# Comhairle Chontae Atha Cliath Theas

## Record of Executive Business and Chief Executive's Order

**Reg. Reference:** SDZ22A/0017      **Application Date:** 02-Dec-2022

**Proposed Development:** Construction of 157 dwellings within the Clonburris South-West Development Area of the Clonburris Strategic Development Zone (SDZ) Planning Scheme 2019 consisting of, 81 houses comprising of 4 two bedroom houses, 65 three bedroom houses and 12 four bedroom houses (all two storey with associated private open space and car parking; 76 apartment units consisting of 26 one bedroom and 50 two bedroom units within Block 1 (4 storeys); Vehicular access will be provided from the permitted street under SDZ21A/0022 and the permitted Clonburris Southern Link Street (SDZ20A/0021) and R113 (Fonthill Road) to the east; All ancillary site development works including footpaths, landscaping boundary treatments, public and private open space areas, car parking (170 spaces) and bicycle parking (170 spaces), single storey ESB sub-stations, bin and bicycle stores and all ancillary site development/construction works all on wider lands bounded generally by the Dublin-Cork railway line to the north, undevelope

Figure 1- Overall Street layout proposed.

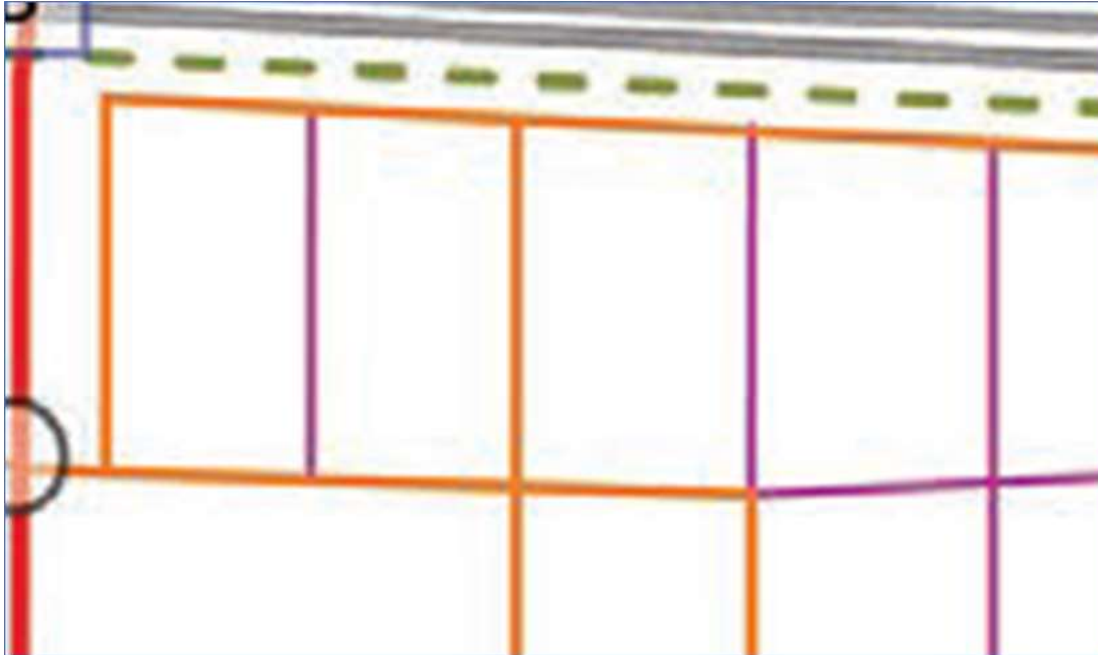
Having regard to the above, it is considered that the movement and street network proposed by the applicant is largely compliant with the planning scheme. The Roads Department has raised some concerns regarding the implementation of matters discussed in the Road Safety Audit that have not been implemented and has requested **additional information**.

The principle of all designated streets in the Planning Scheme is fixed. It is considered that the approach of the proposed development in terms of street designation is generally consistent with the Planning Scheme.

**Figure 2.2.6** Example Local Streets including Homezones (Intimate Scale)

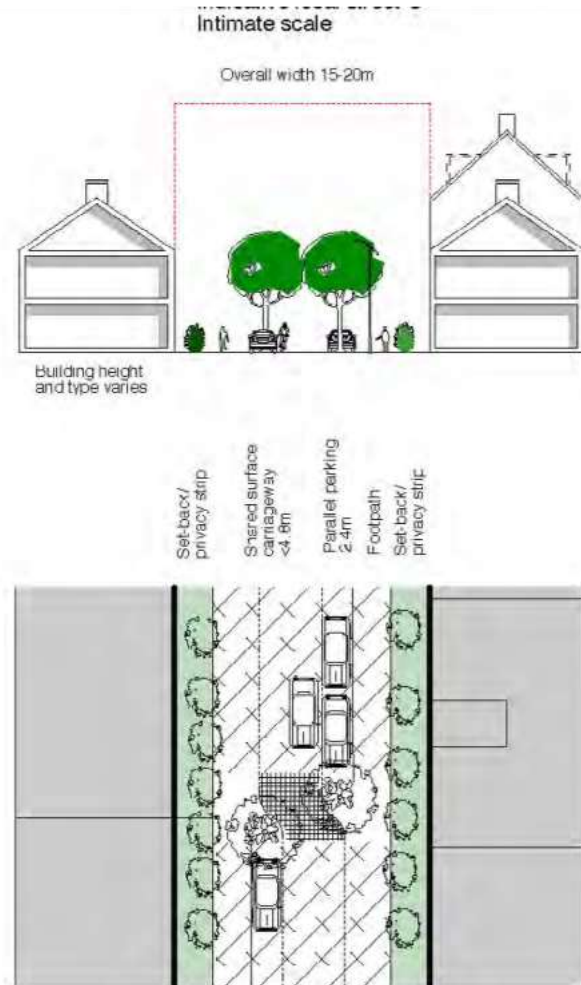
- Street 12: Generally, meets indicative local street. On curtilage parking is provided in part, which is in keeping with the scheme provided overall provision is less than 60%. There are concerns regarding the design of the area to the south of the apartment block (Block 1), which does not provide parking, nor does it provide a min. 2.5m wide footpath (only 2m is provided at this location).
- Street 13: No opposing buildings. Generally, meets indicative local street A. On curtilage parking is provided in part, which is in keeping with the scheme provided overall provision is less than 60%. There are concerns regarding the design of the area to the north of the apartment block (Block 1), which does not provide parking nor does it provide a min. 2.5m wide footpath (only 2m is provided at this location).

- Street 14: No opposing buildings. Generally, meets indicative local street A. Footpath is only 2m wide and should be increased to 2.5m. An area of open space is identified at this location within the scheme and it is also identified as a strategic green corridor. It is noted that there are significant levels of parking along this street, which are necessary for the apartments. In light of the GI designations in this area, the applicant is requested to provide for a Homezone along Street 14, along the north of the apartments to meet Street 15. There should be a significant increase in the level of planning and GI in this area also.

- Street 18: Generally, meets indicative local street A (when considered with information provided on adjacent application). The scheme requires intimate local street at this location and the applicant is requested to provide a rationale for their approach.

Where perpendicular parking is proposed, the applicant is requested to indicate that there is a 6m reversing space. The applicant is requested to provide a plan setting out the dimensions of all street widths, in compliance with the scheme, and all foot paths, carriageways and parking bays.

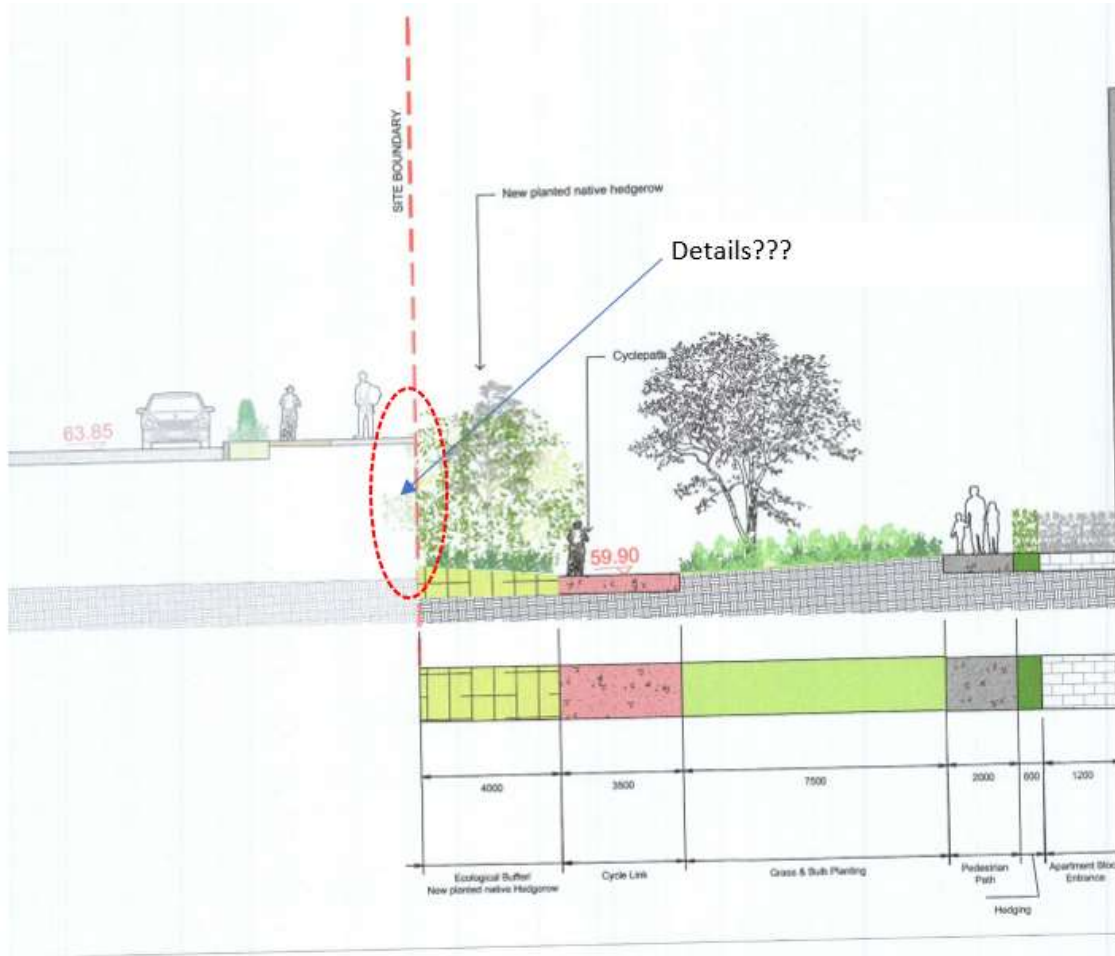
The Parks Department has concerns regarding the lack of north south strategic corridor, the loss of hedgerow 8, the lack of SuDS and play areas.

- 1. *“Insufficient Information on how this development impacts on the provision of the Strategic Green Link and bridge over the railway line. There is insufficient information to show how this development will link to the bridge or what happens to the cycle path running along the northern boundary. It may restrict the development of that link. There is no retaining wall or any details to show that what is proposed is even possible. There is no retaining wall or other structure to support the roadway and this development could not be built as proposed in this application.*

3. *Impact on existing hedgerows and biodiversity: Hedge 8 is specifically identified to be retained as part of the SDZ. As one of very few hedgerows proposed to be retained in Clonburris removal would set a very dangerous precedent.*
4. *Public Open Space requirement. A new strategic open space identified in the SDZ has not been provided. A road, parking and ramps are currently proposed in this area. This space is required to create the Strategic Green Corridor through Clonburris and fragmentation would weaken the entire Green Infrastructure network in Clonburris.*
